Office Action Summary

10/689,141

This Office Action represents a non-final first Office Action for the application titled "FRAME FOR PRESSURIZED FLUID APPARATUS," filed October 20, 2003.

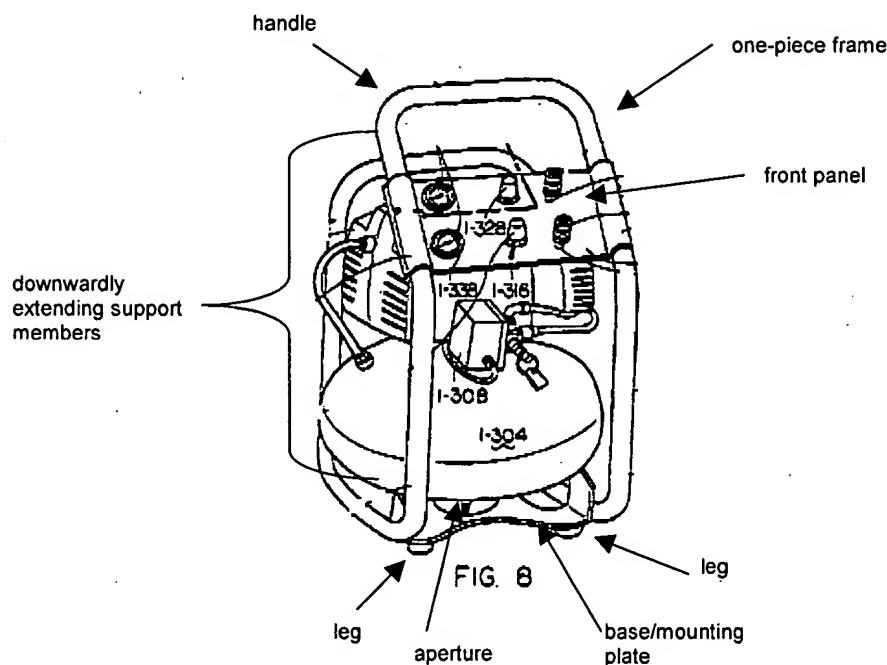
Wood discloses an integrally formed stackable one-piece frame, as shown above, comprising: a base that is capable of supporting a power unit; at least one leg that supports the base on a surface, an integrally formed handle having a pair of downwardly extending support members, said pair of downwardly extending support members are substantially parallel to the at least one leg and contiguous with the at least one leg, a power unit having an engine, a base having an aperture and a mounting

plate, said at least one leg includes a plurality of legs, a pair of downwardly extending support members that form an acute included angle with the base in the YZ-plane.

Regarding claims 20-22, 24-26, and 29-31, Wood et al. discloses the stackable frame, as shown in the figure above, comprising: an integrally formed one-piece frame for an apparatus that supplies a pressurized fluid, the frame comprising: a base that supports a power unit; a first base support member integrally formed with the base that supports the base on a surface; a second base support member integrally formed with the base that supports the base on the surface; an integrally formed handle; an integrally formed front panel, support members that are substantially parallel to the first and second base support members, said support members contiguous with the first and

Wood et al. discloses the stackable frame, as shown in the figure above, comprising: an integrally formed one-piece frame for an apparatus that supplies a pressurized fluid, the frame comprising: a base that supports a power unit; at least one base support member that supports the base on a surface; said one base support member including first, second, third, and fourth base support members, and a handle including an upper end, a first support member defining a first axis, a second support member defining a second axis, said first and second support members each form an acute included angle with the base in the YZ-plane, said first and second support members are substantially parallel to the at least one base support member, said first and second support members are contiguous with the at least one base support member, but does not teach the first and second axes each forming an acute included
